**Response to Comments**  
**on the**  
**Draft NEWIOU Feasibility Study**

## Response to CIWMB Comments on the Draft Feasibility Study for the NEWIOU

IRP Site SS029

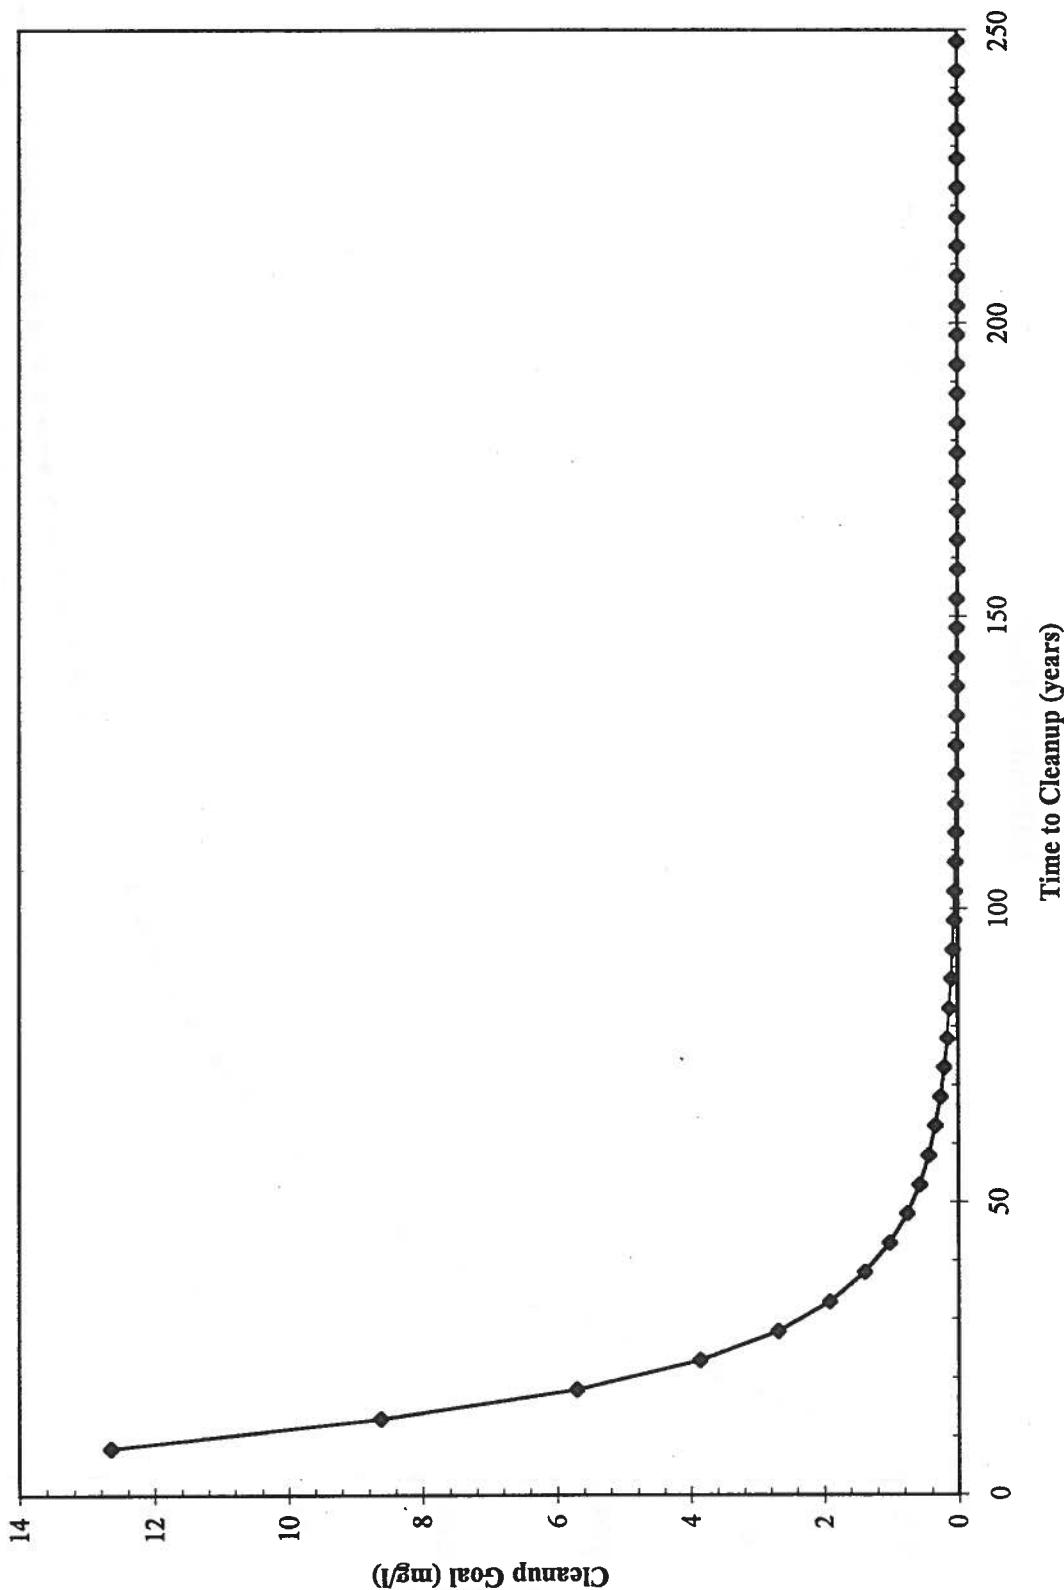
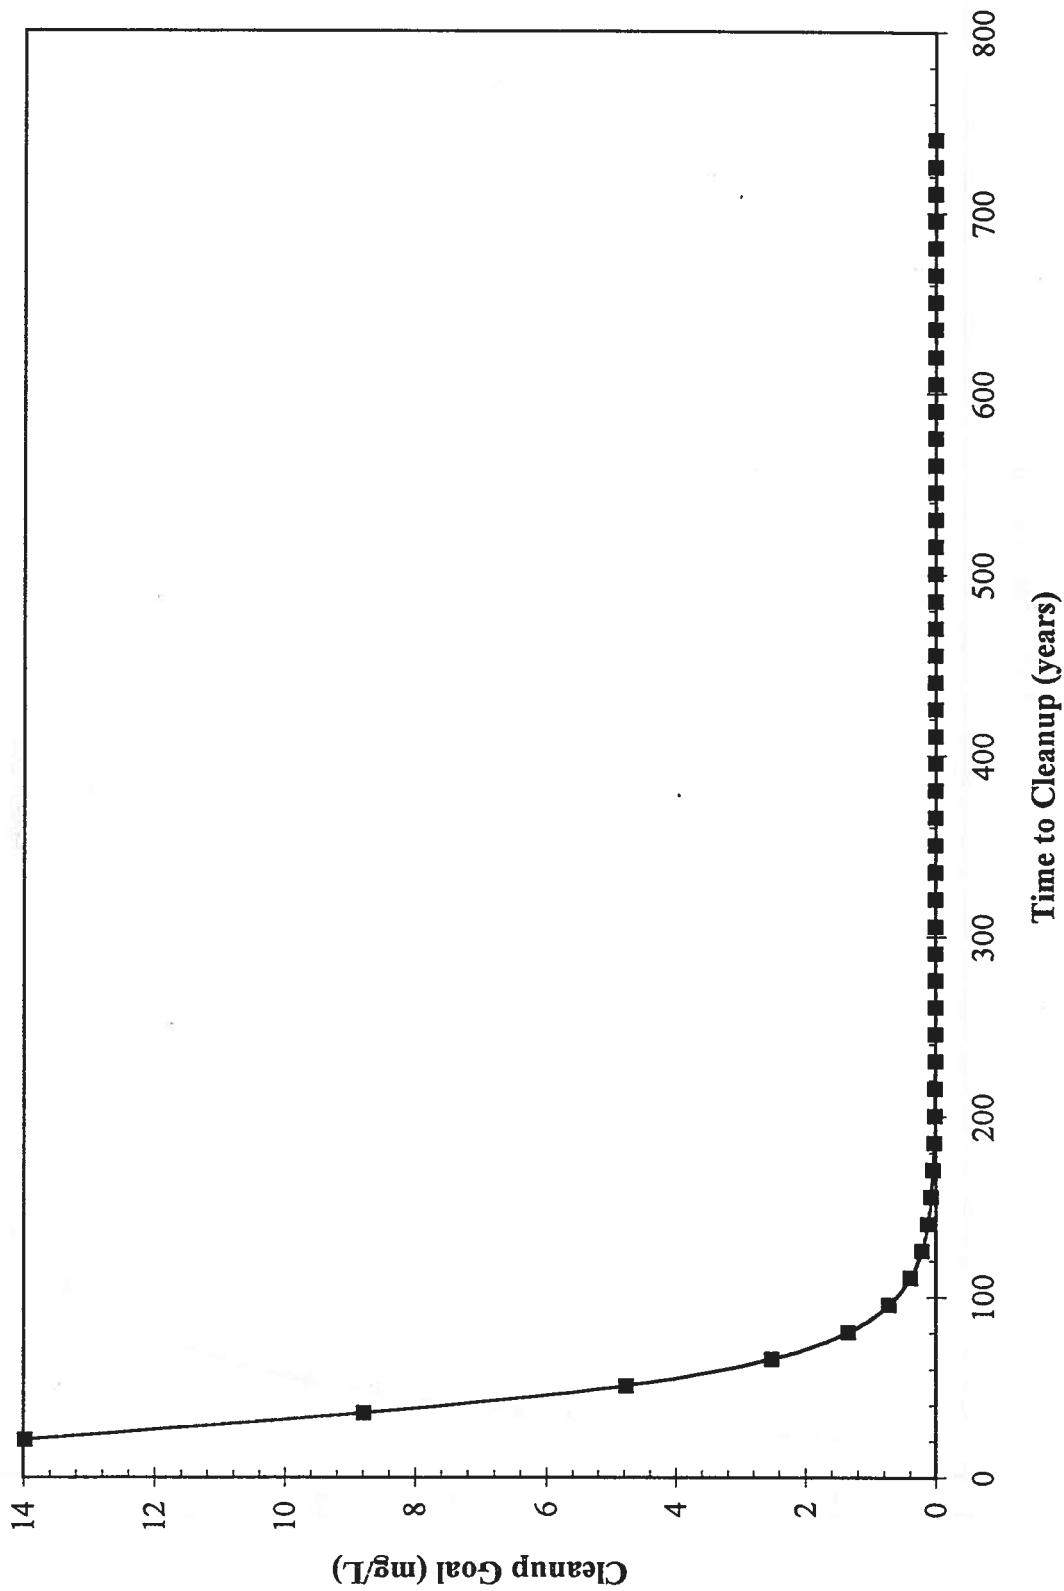
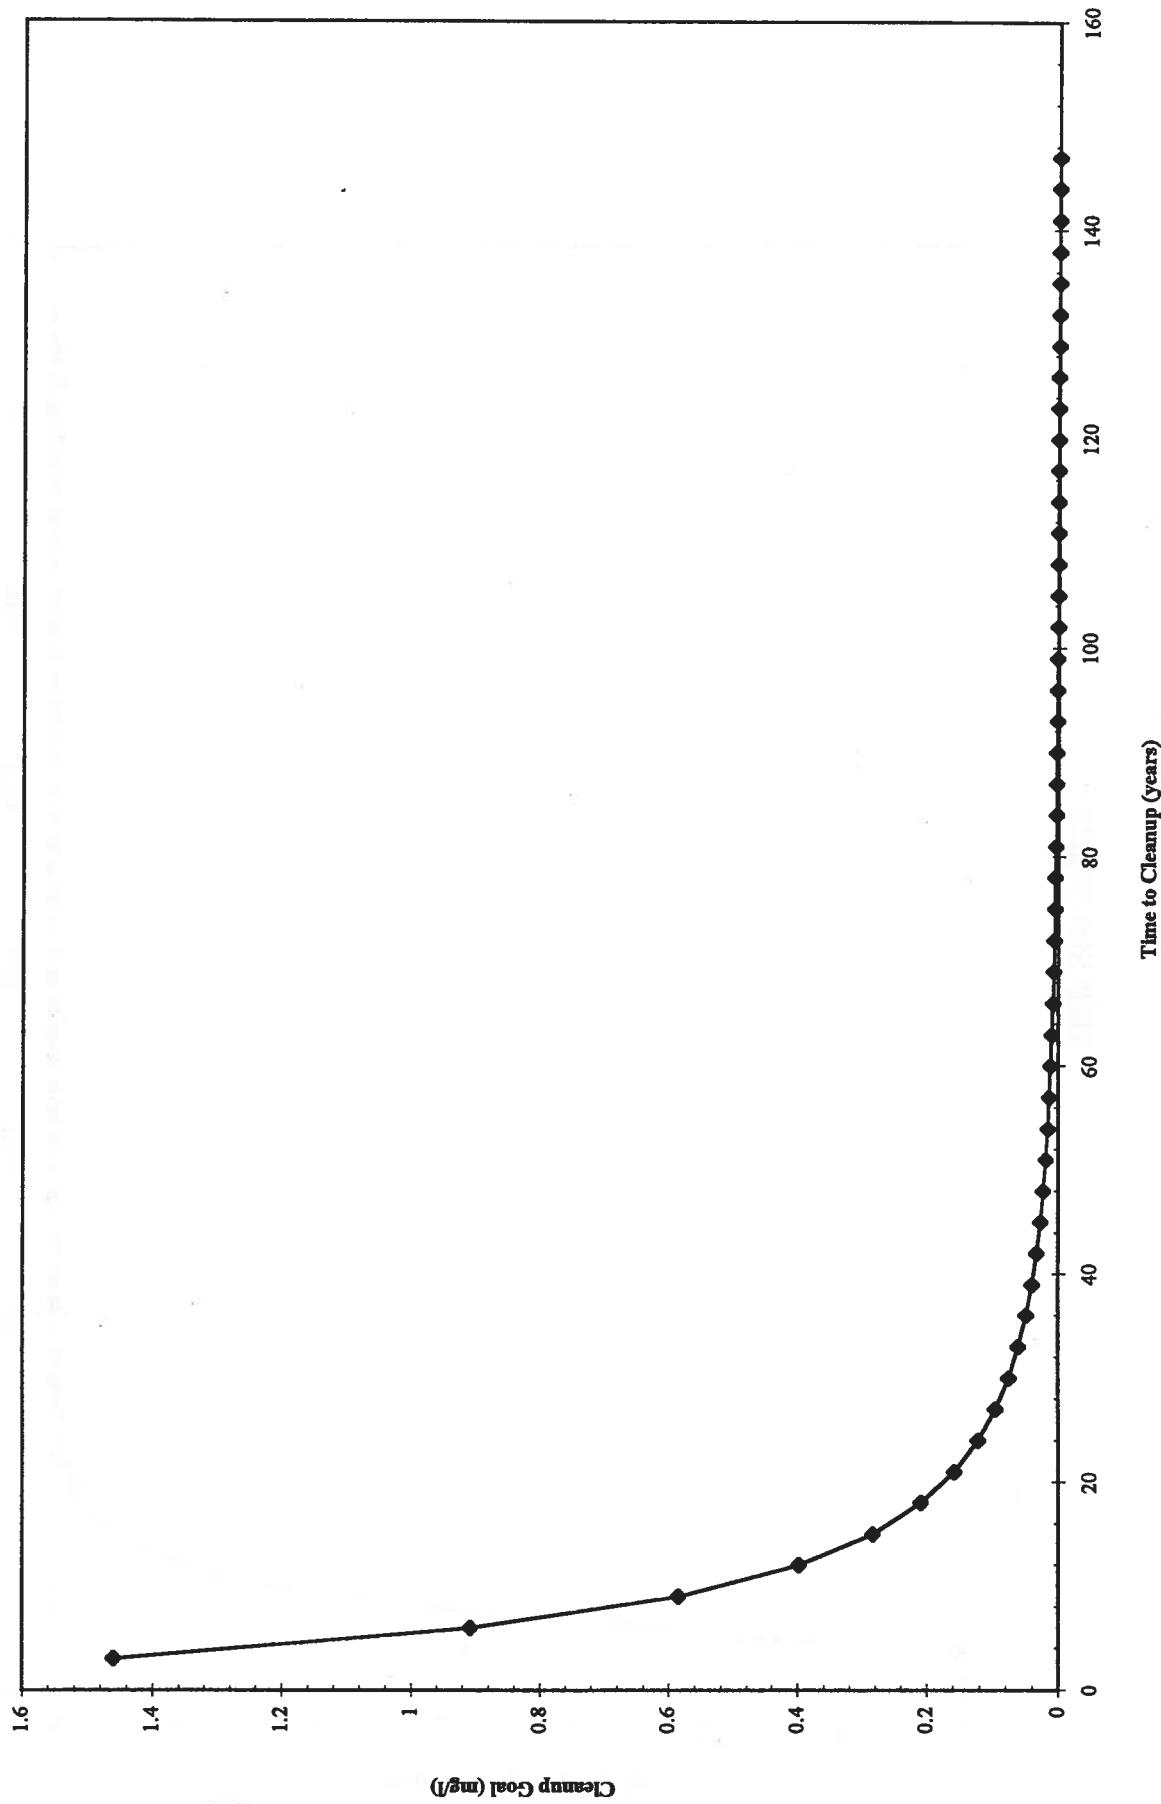
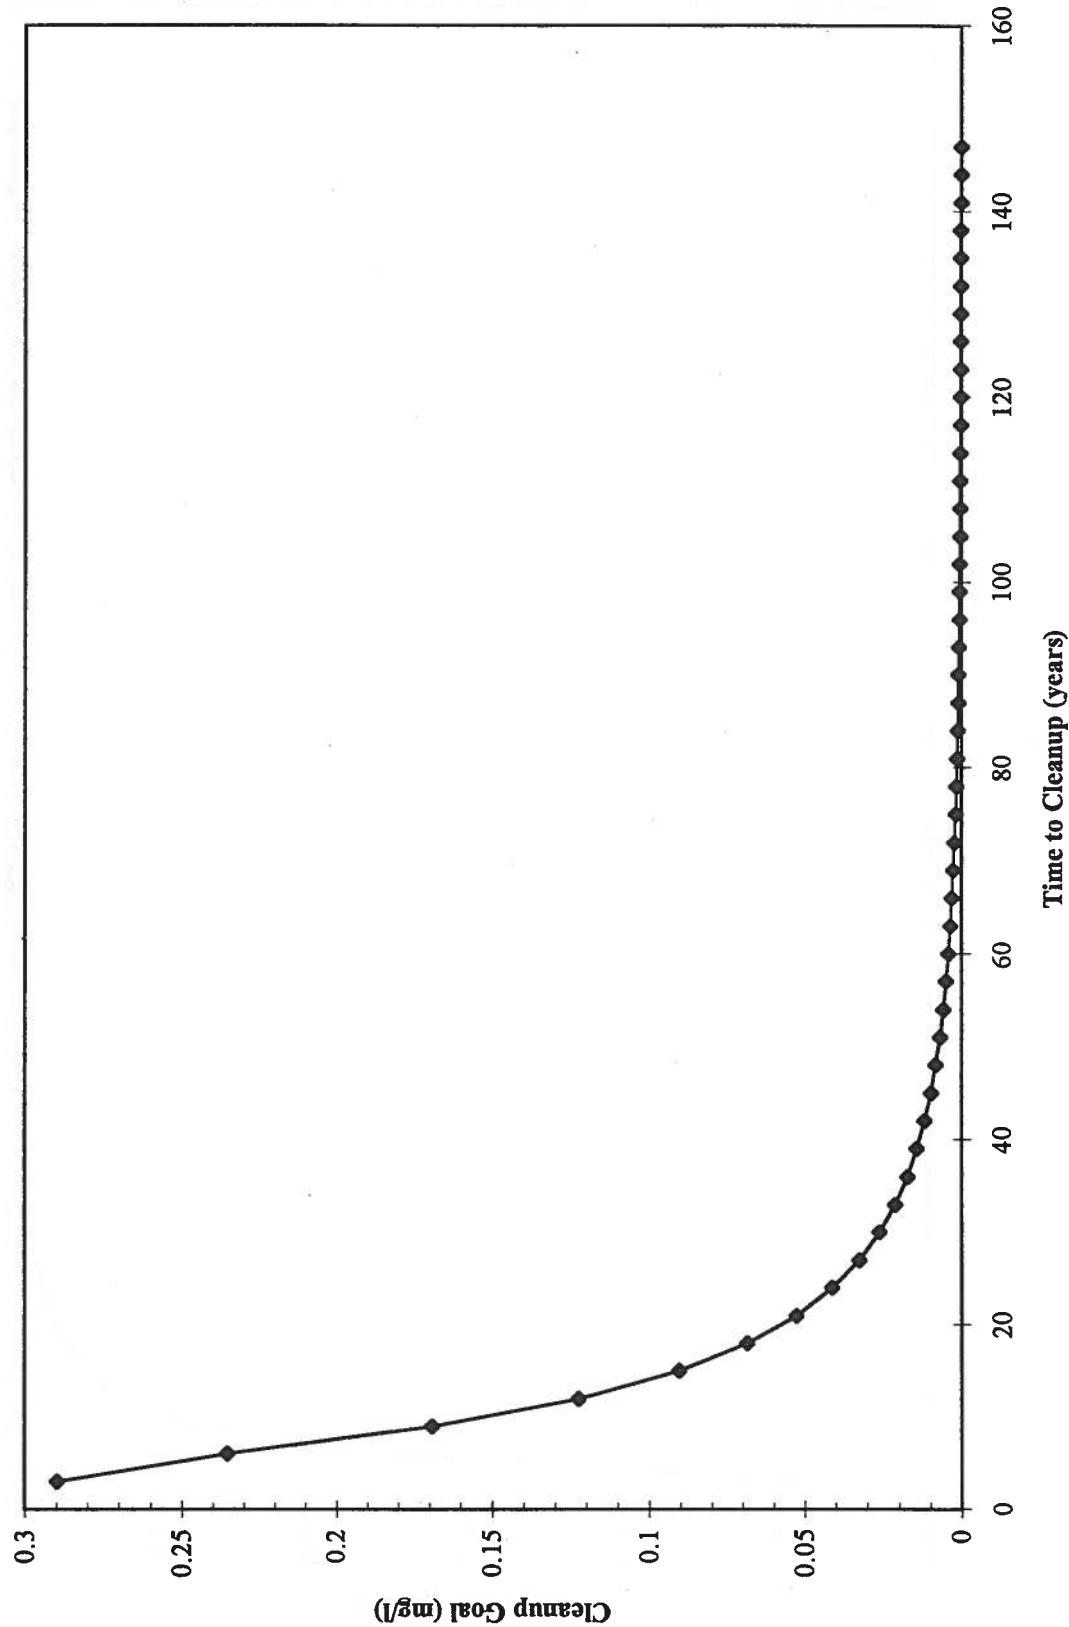
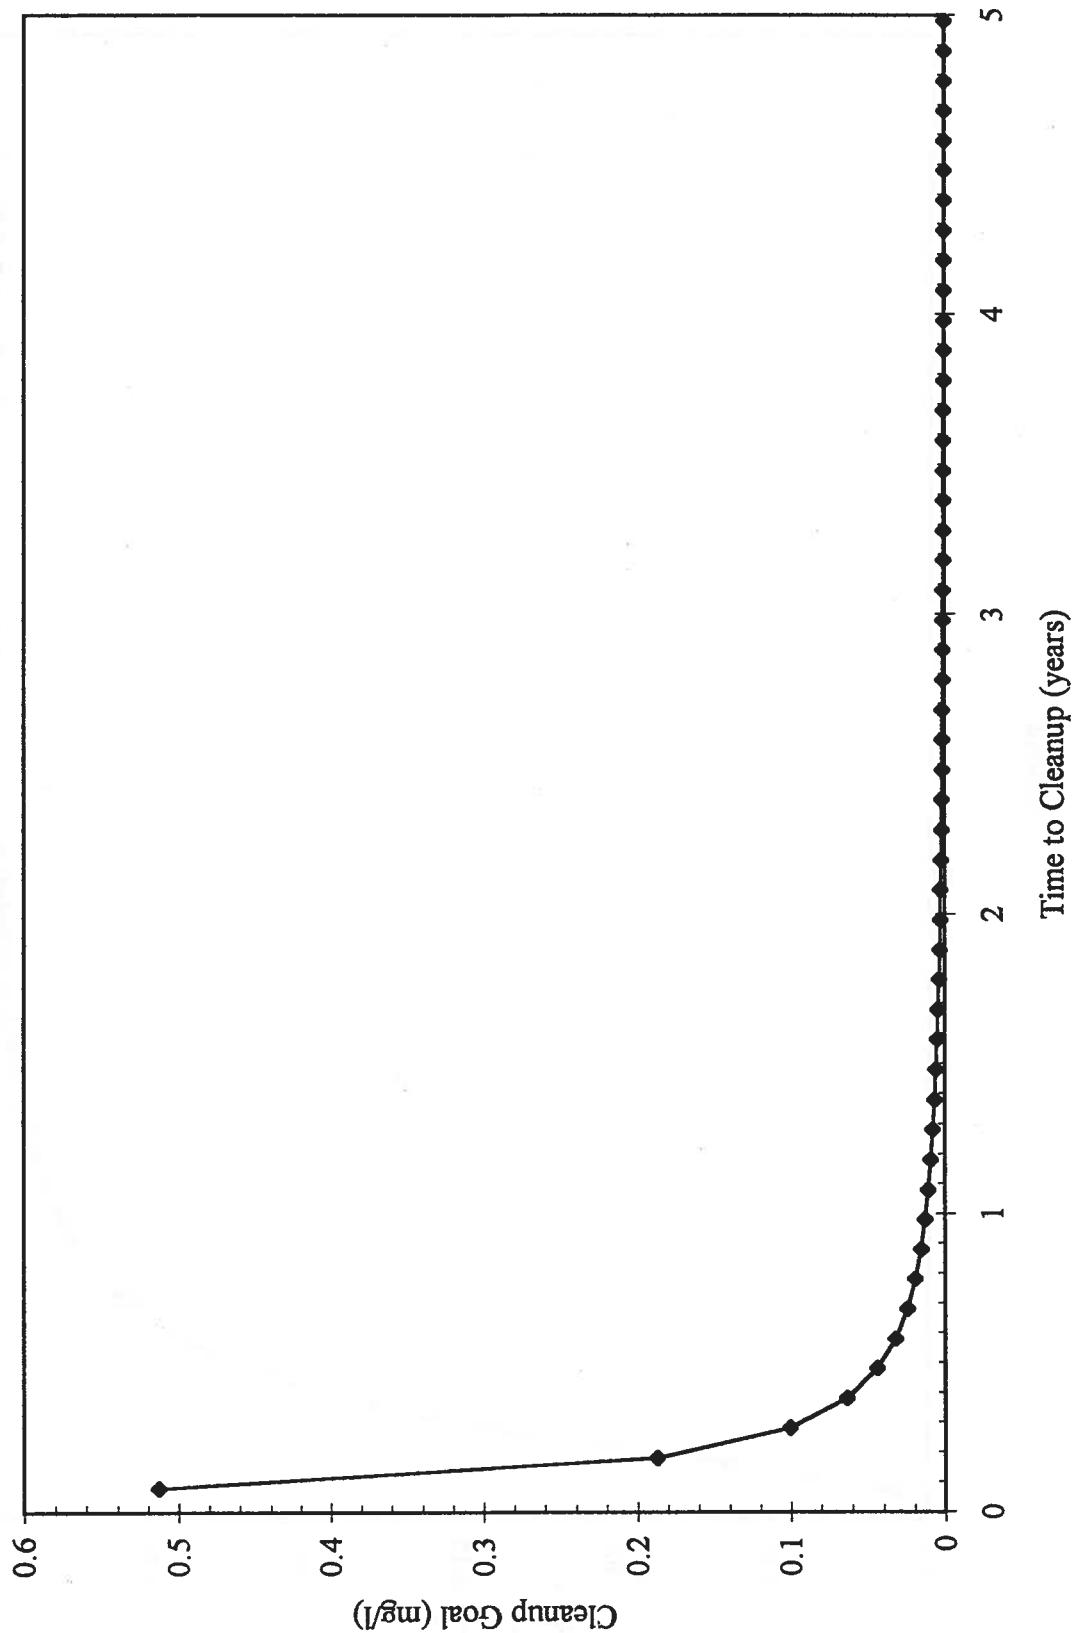
No.	Comments	Responses/Notes
13	<p><b>Appendix C, Time to Cleanup Determination Procedure</b></p> <p><b>Table C-10, Time to Cleanup Results</b></p> <p>For Group A sites, LF007B, LF007C, and LF007D, there is an apparent discrepancy in the calculated time to clean up the corresponding plumes and the relative size of those plumes. For example, the plumes under LF007D and LF007B are larger than the plume under LF007C and yet the calculated clean up time for LF007C is approximately ten times greater than LF007D and LF007B. DTSC recommends that the calculations be redone to check for possible errors. If the calculations are correct, then a discussion is needed to explain why there is such a large variation in cleanup times between LF007C and LF007B/LF007D. Any changes made to this table will also require modification of corresponding figures and discussion in the rest of the report.</p>	<p>The calculations for LF006 and LF007C were incorrect. The times to cleanup LF006 and LF007C should be lower. These times to cleanup have been corrected. In addition, an explanation of the following differences will be added to the Appendix: LF007B and LF007D were modeled based on chlorobenzene, while LF007C was modeled based on TCE, as noted in the summary table. In addition, LF007B and LF007C were modeled for linear flow through the plume, while LF007D was modeled for radial flow from the center of the plume.</p>
